UNITED STATES PATENT AND TRADEMARK OFFICE

10/802,890

Office Action Summary

DETAILED ACTION

SHEET 1 OF 2

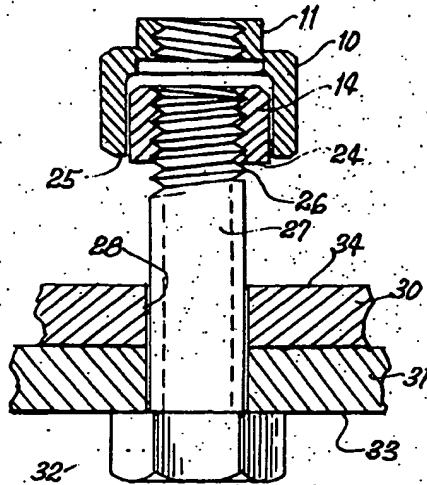
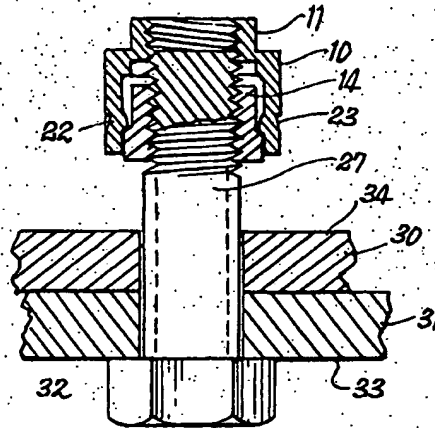
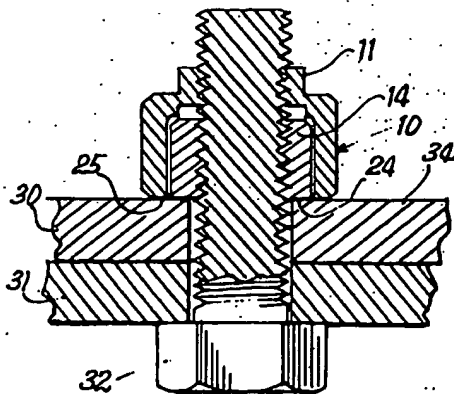
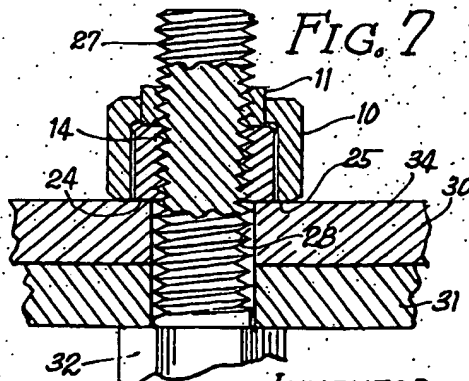
Grube teaches a washer with a body having an axis and first and second axial outer facial surfaces. Further, the washer has an additional turning resistant surface adapted to cooperate with a bolt, said additional turning resistant surface providing friction between the body and bolt to impede the bolt from turning and allowing the bolt to be axially displaced when the nut is turned (abstract Figs 4-7, col 3 line 59 - col 5 line 58). Grube Figs 4-7 teach the assembly of a washer in combination with the bolt.

Fig 4-7 show the turning resistant surface connectable with a bolt thread.

Fig. 4-7 show the body movable in the axial direction, and with one portion provided with said additional turning resistant surface and another portion frictionally connected to said one portion and provided with said second face surface which is adapted to frictionally cooperate with the object (at 24/25).

A breaking point is shown in Figs 6-7, which when broken when the bolt is turned, elongates the bolt in the axial direction.

First, examiner notes that claims 1-8 do not include the bolt or nut, and the washer stands alone, and thus either face can be considered the first or second face of the washer and either part 11, part 14, or the combination can be considered the washer. It is possible to add another lock nut onto the protruding shaft end 27, which is all the claims require.
